# ALLENDALE CHARTER TOWNSHIP PLANNING COMMISSION MEETING

We have received and reviewed the plan submittal for the proposed Allendale Christian School Expansion. The following sheets were received and reviewed, all dated April 22<sup>nd</sup>, 2021:

> Re: Site Plan and Special Use Review for Allendale Christian School Expansion 11050 64th Avenue, Allendale, MI

#### SPECIAL USE AND SITE PLAN REVIEW ALLENDALE CHRISTIAN SCHOOL DATE: May 11, 2021 PAGE 1 of 11

G-100

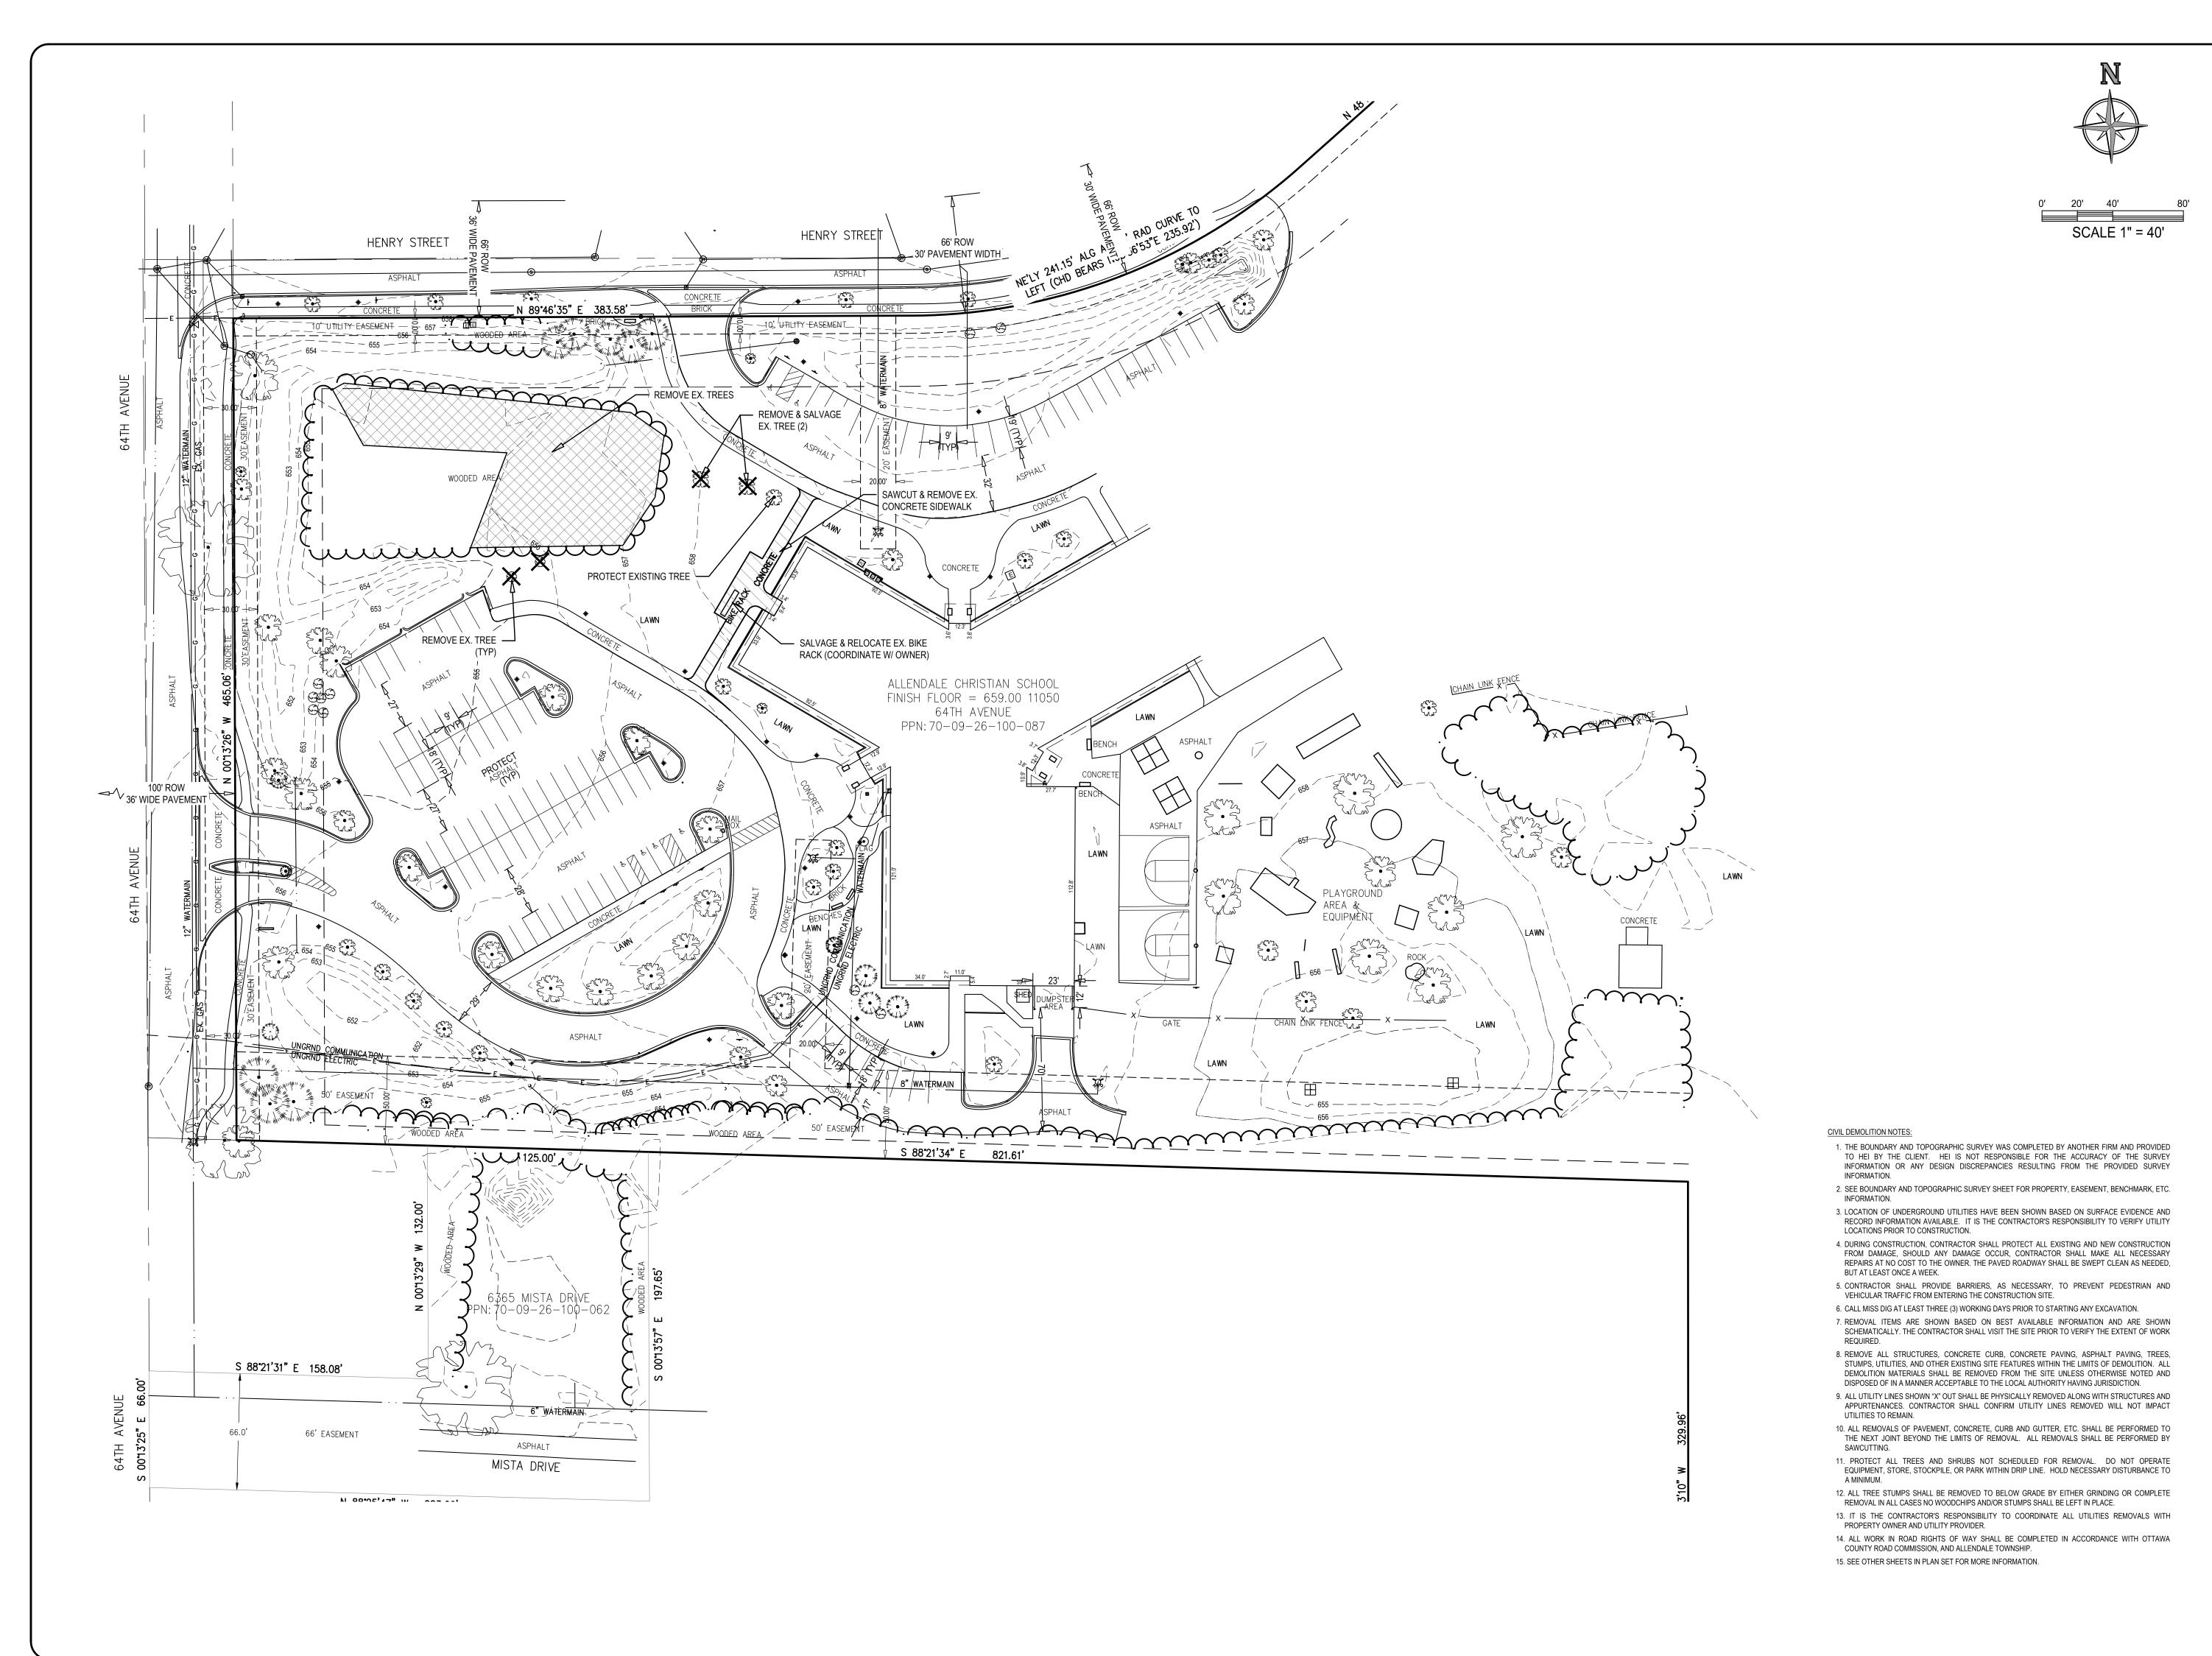
Sheet G-100:

**Response:** A scale has been added to the map of the site location on Sheet G-100 for reference on the site location in the Township.

Sheet Title CIVIL **DEMOLITION**

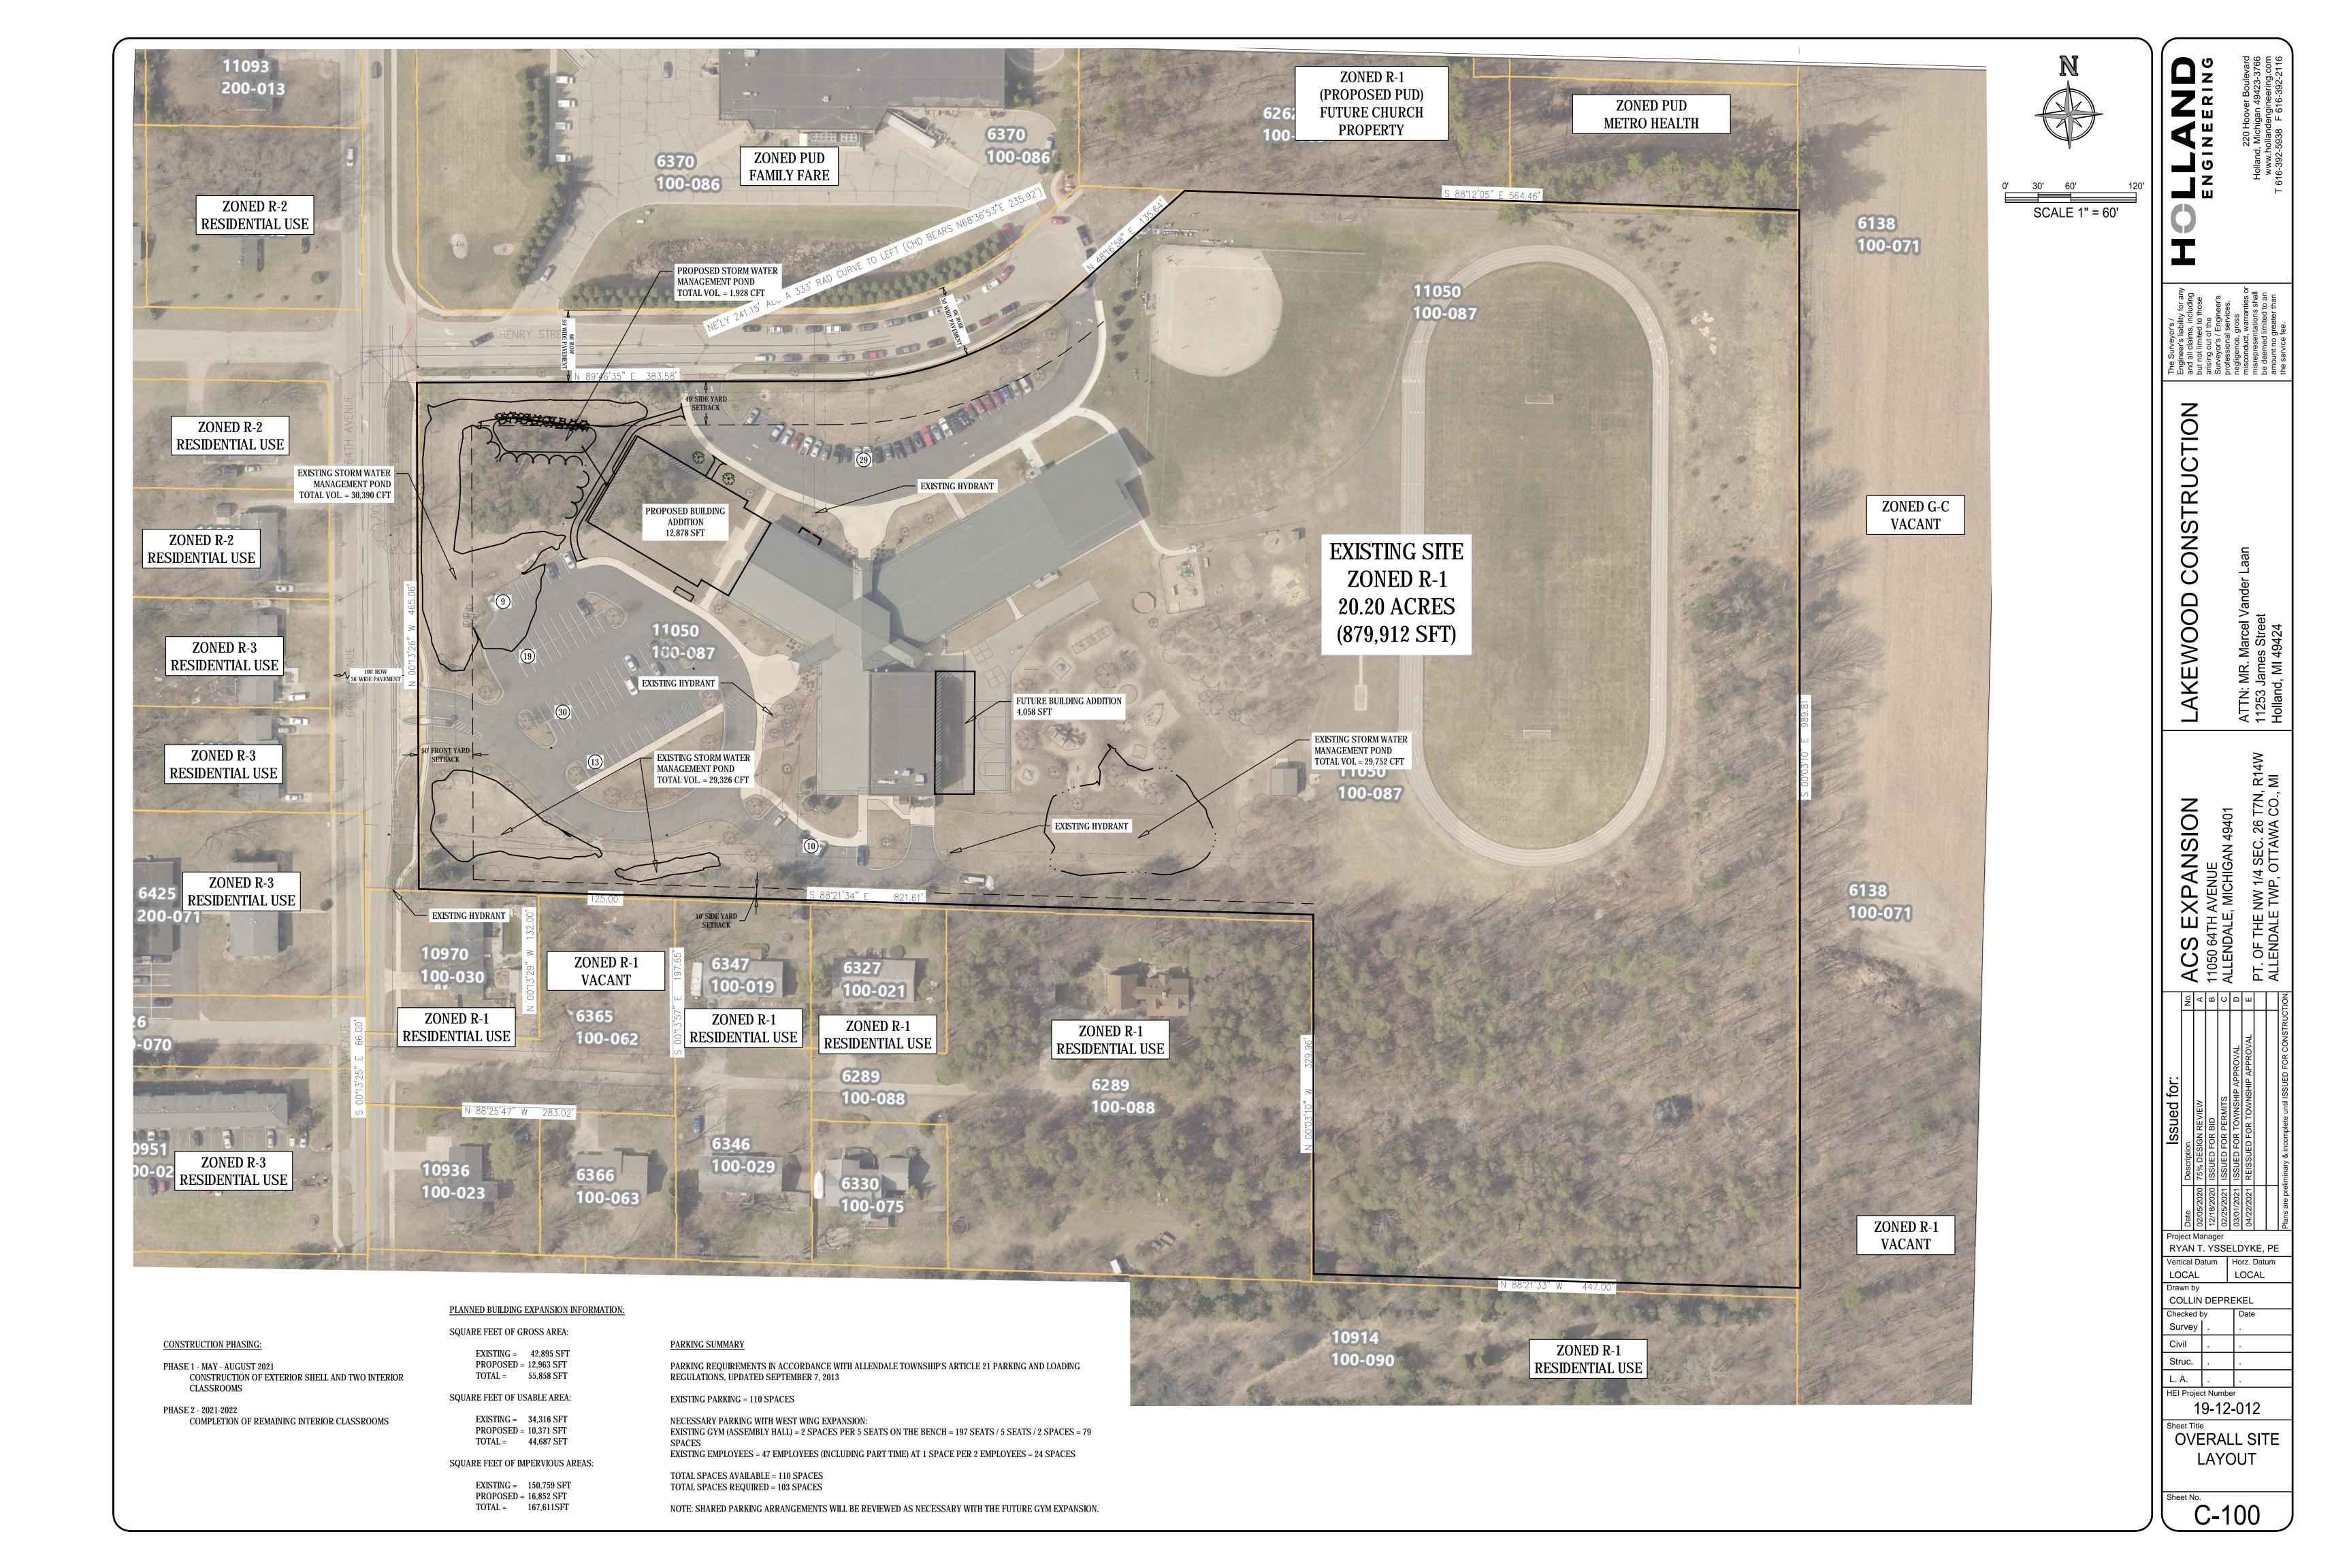
Sheet CD - 101:

Please provide dimensions of existing parking (Section 21.09)

Response: Additional dimensions have been provided on Sheet CD-101.

**Response:** Additional dimensional information has been added to Sheet CD-101 regarding the size and configuration of the existing dumpster enclosure. Additional information has also been added to the narrative.
